BOARDS & COMMISSIONS APPLICATION

Z25-22

Hotel and Event Center Signs

Request: Sign Variance to Section 1147.07(b)(4) to allow backlit signs and Section 1147.15(c) to allow both ground signs and building signs, building signs larger than permitted, and a building sign on non-building frontage

E03

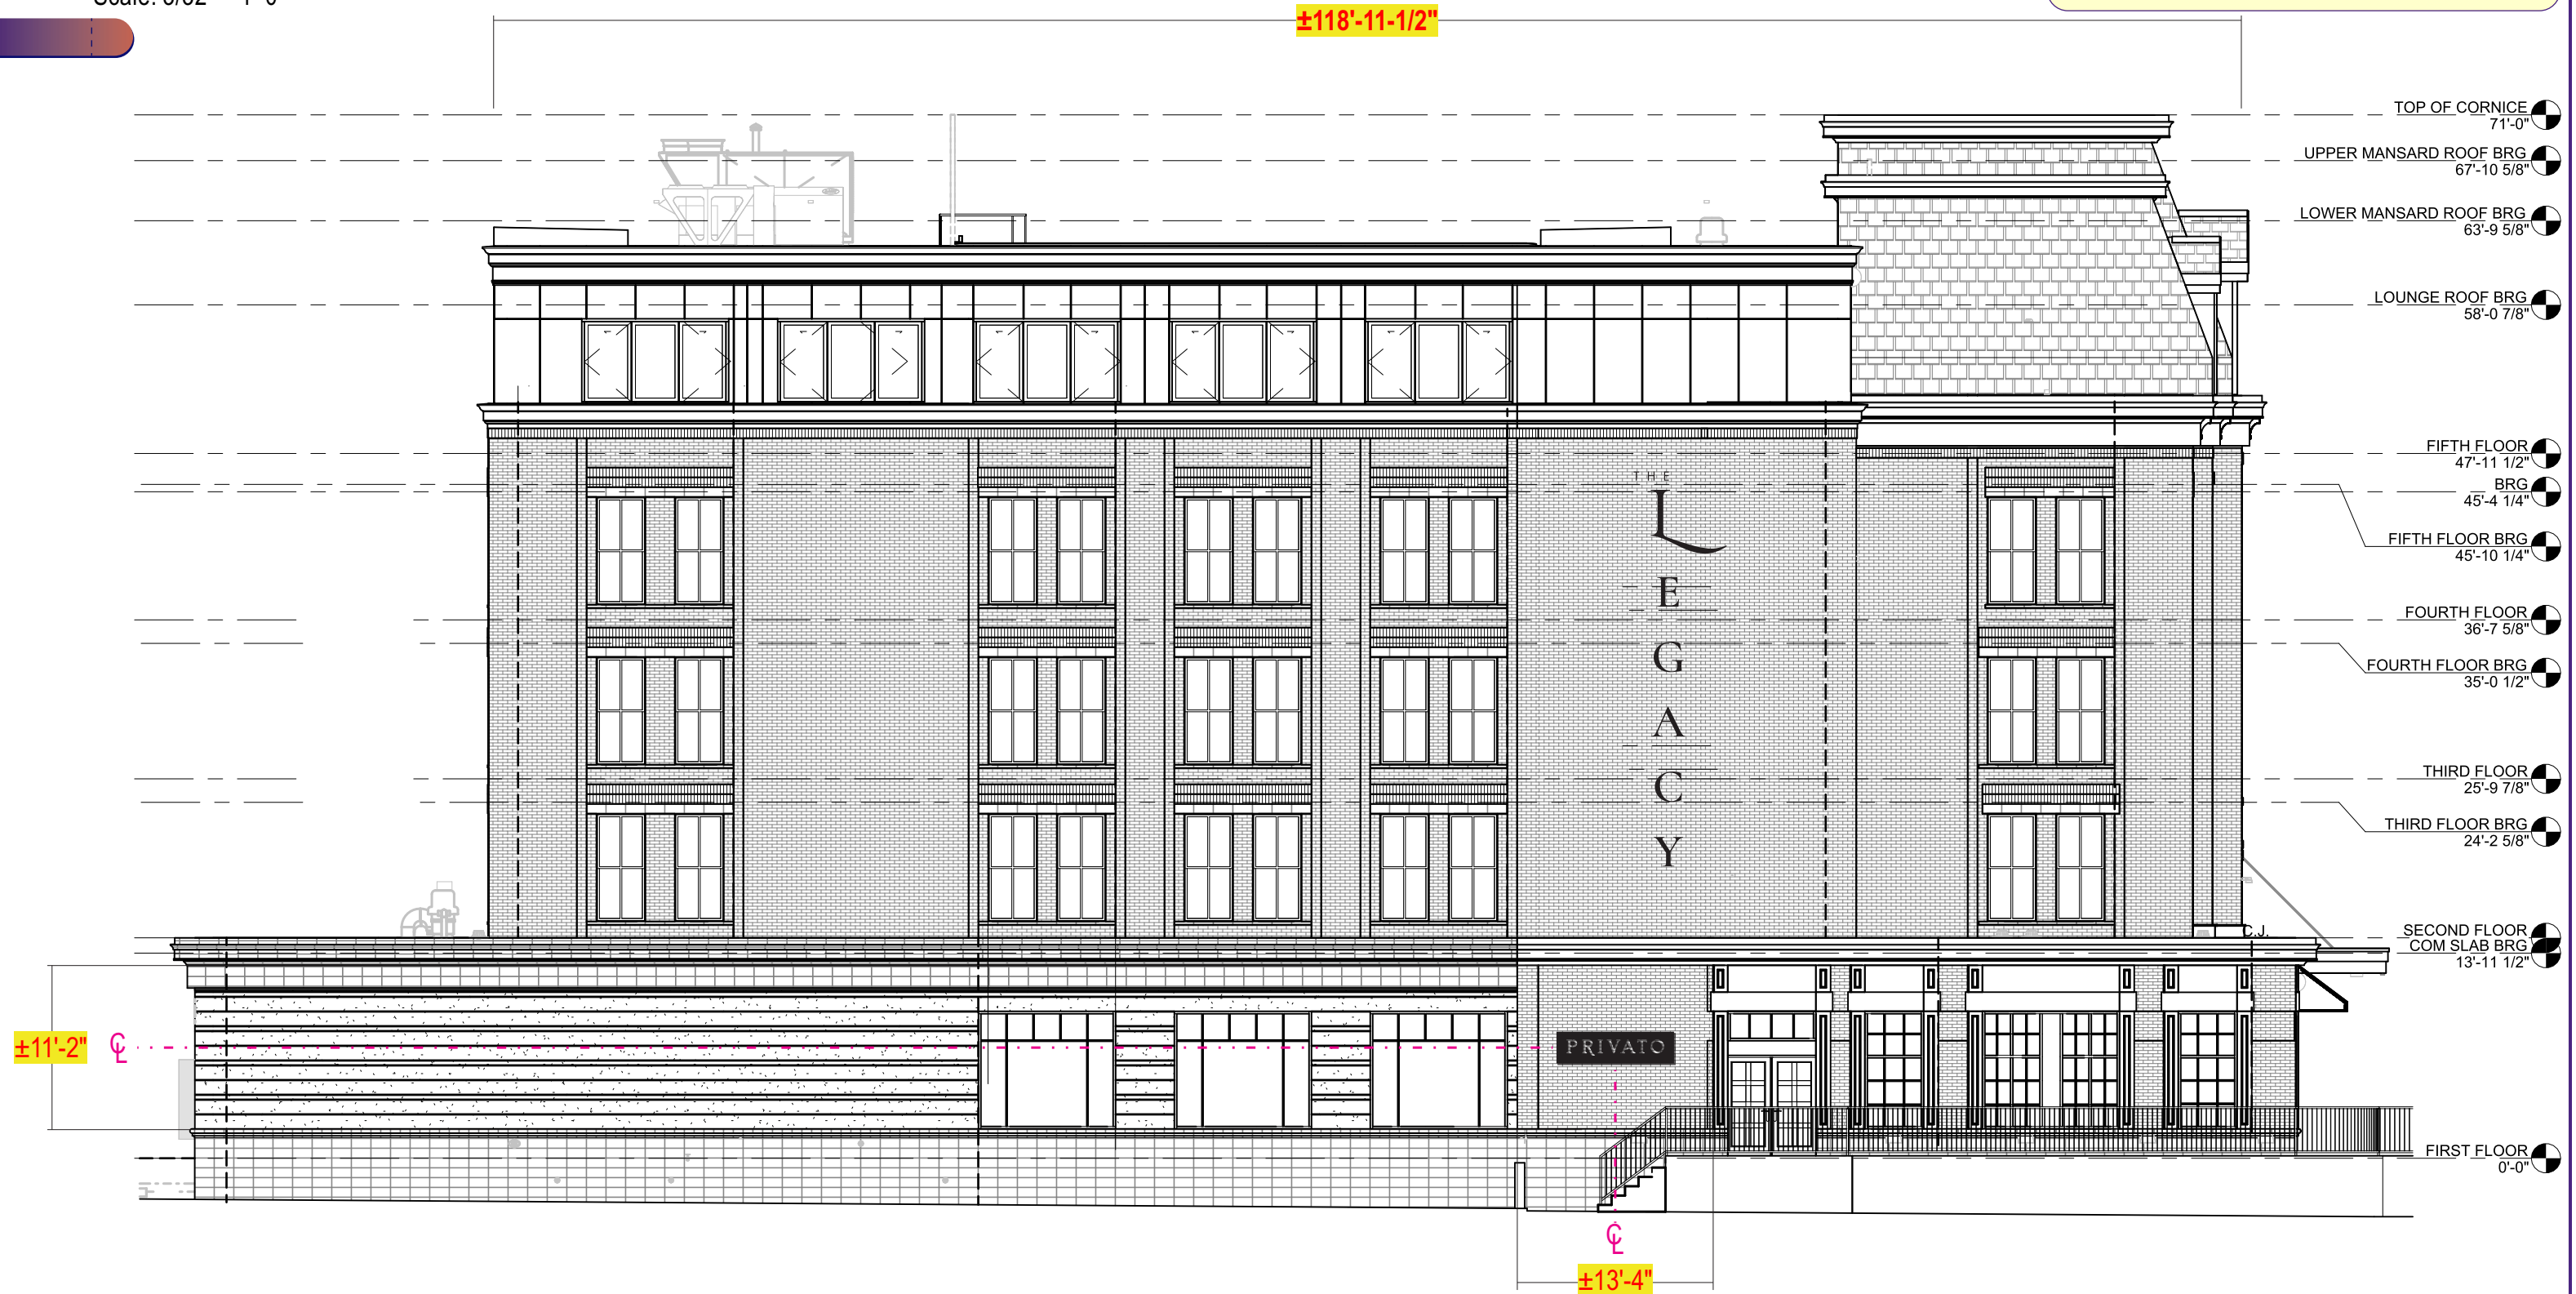
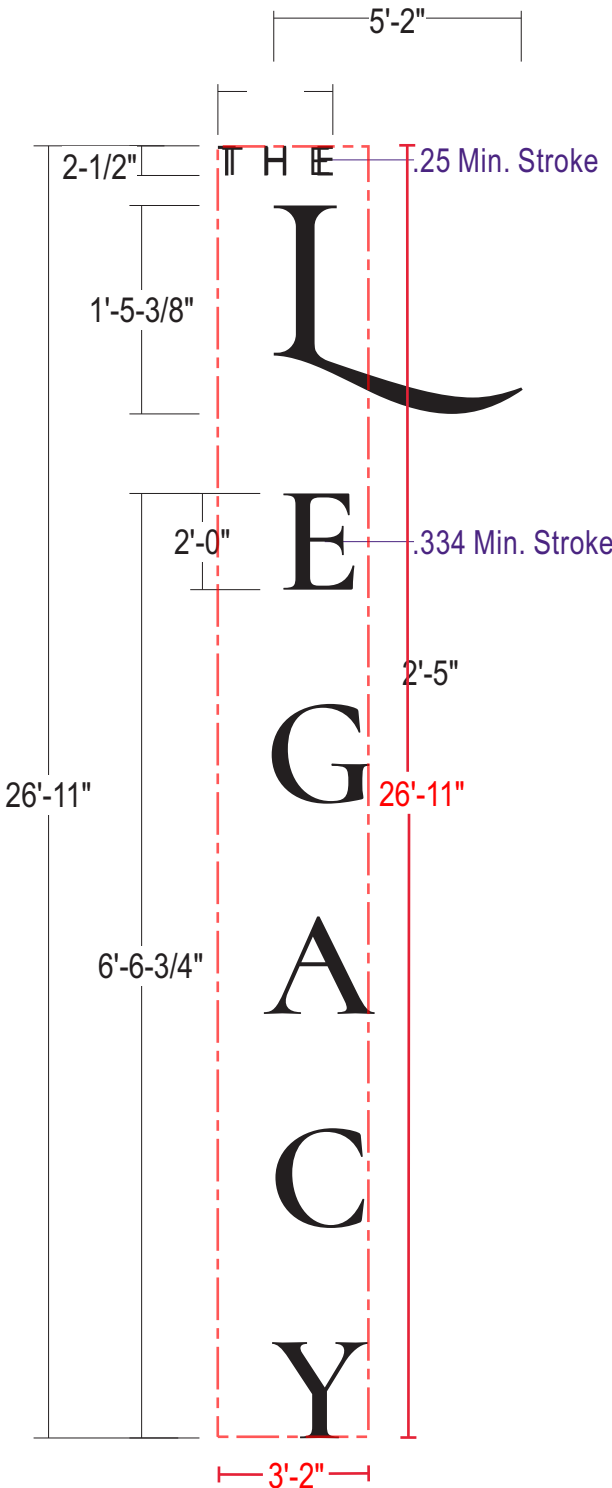
As noted in the table above, the "Legacy" wall sign (E01) is internally illuminated. In addition, the "Legacy" wall sign (E03), "Privato" wall sign (E05), and two "LL" wall signs (E08 & E09) are backlit.

Signs are either non-illuminated, externally illuminated, or internally illuminated. Though backlit signs do not fall into a clear classification, staff has determined that backlit signs are considered internally illuminated, thus requiring a variance.
